**From:** Chavez, Carl J, EMNRD  
**Sent:** Tuesday, June 27, 2017 9 41 AM  
**To:** 'Gary Schubert'  
**Cc:** Griswold, Jim, EMNRD, Whitaker, Mark A, EMNRD, Fortner, Kerry, EMNRD  
**Subject:** RE BW-36 Schubert Farms Well No 1 (API# 30-025-37548) OCD June 2, 2017 MIT Approval

**HRC Inc. Schubert Farms Brine Well No. 1 (BW-36)**

Re HRC Inc Schubert Farms Brine Well No 1 (BW-36)  
API#230-025-2976

#9501  
AA 1000  
JSE

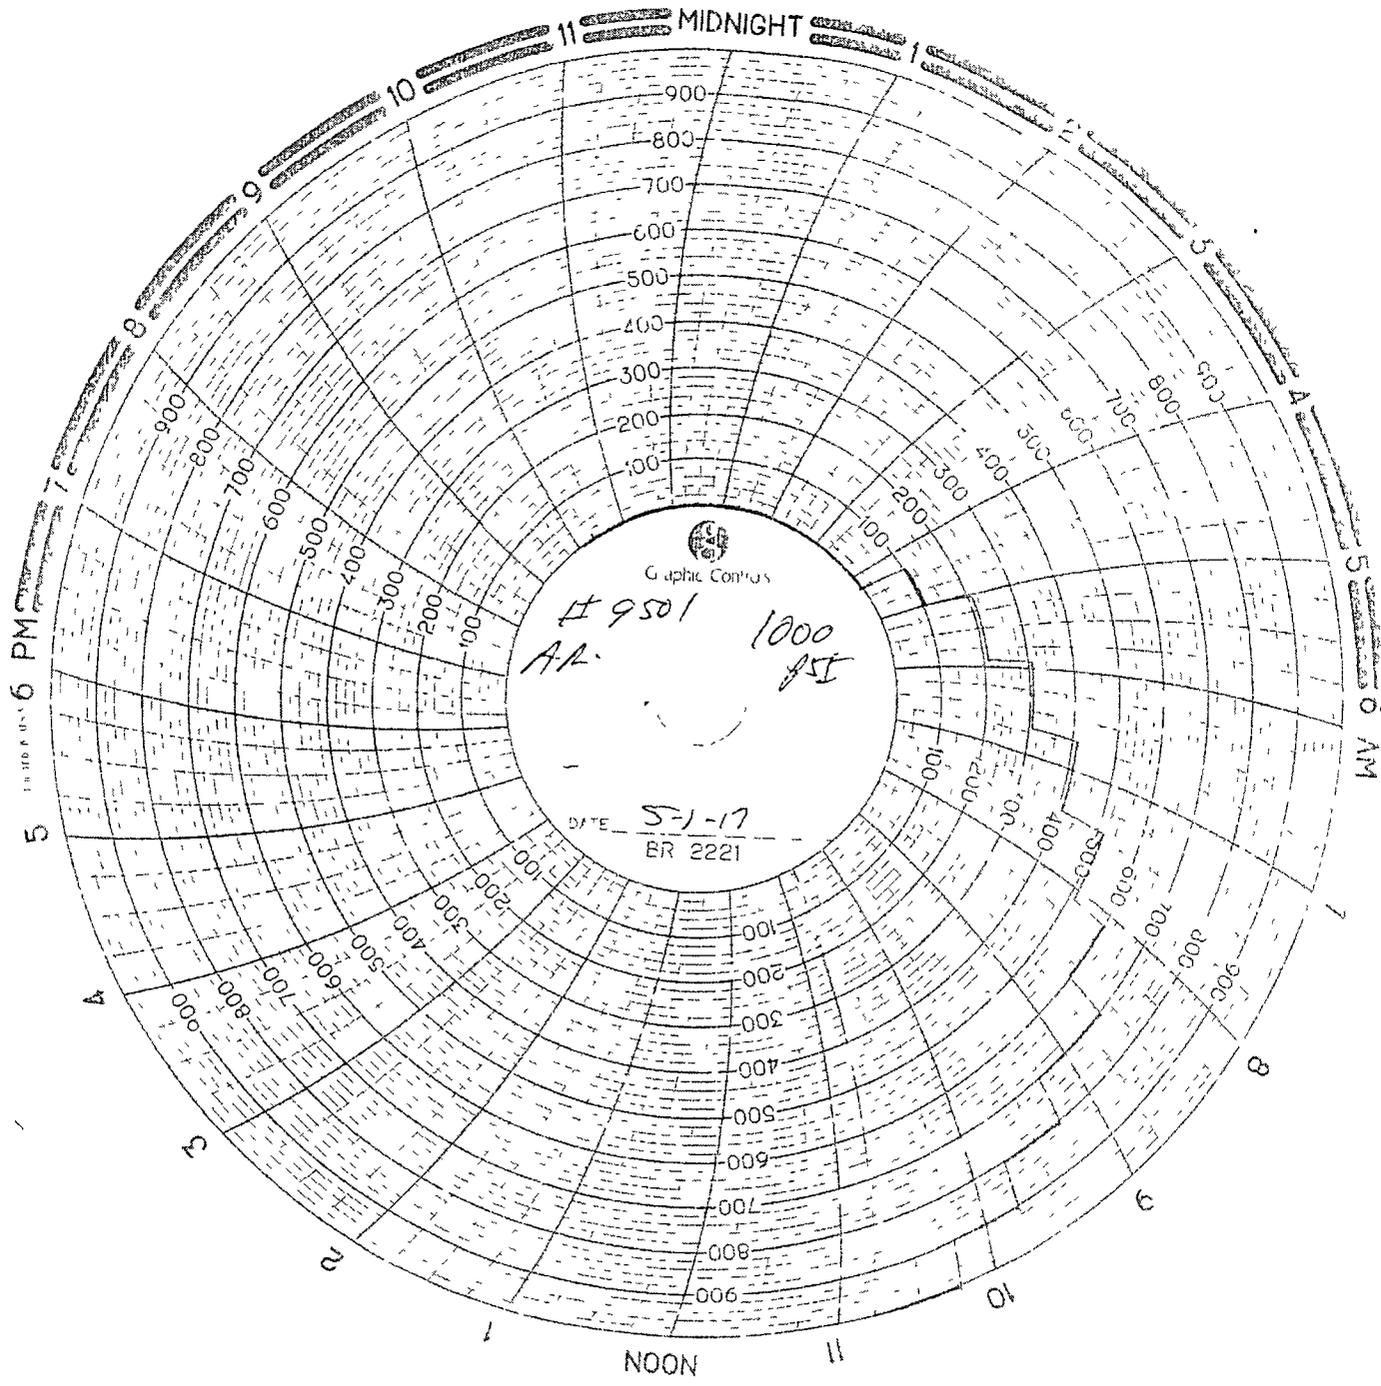
OCD review and reading from the original MIT chart indicates a start pressure of 325 psig and end pressure of 300 psig. However, based on the spring weight, 24-hr chart scale, and clock speed, etc run for the MIT, OCD does not discount your stated pressures below

3 It is my opinion that since the formation cavern volume is as you stated virtually nil any seepage or saturation of fluid into the formation (which had previously not seen anything above static pressure) would show more than normal pressure drop (because of the small cavern volume). I see no spike or irregular "blip" on the chart that would indicate a leak out of the salt formation.

OCD has determined that the above subject well MIT passed.
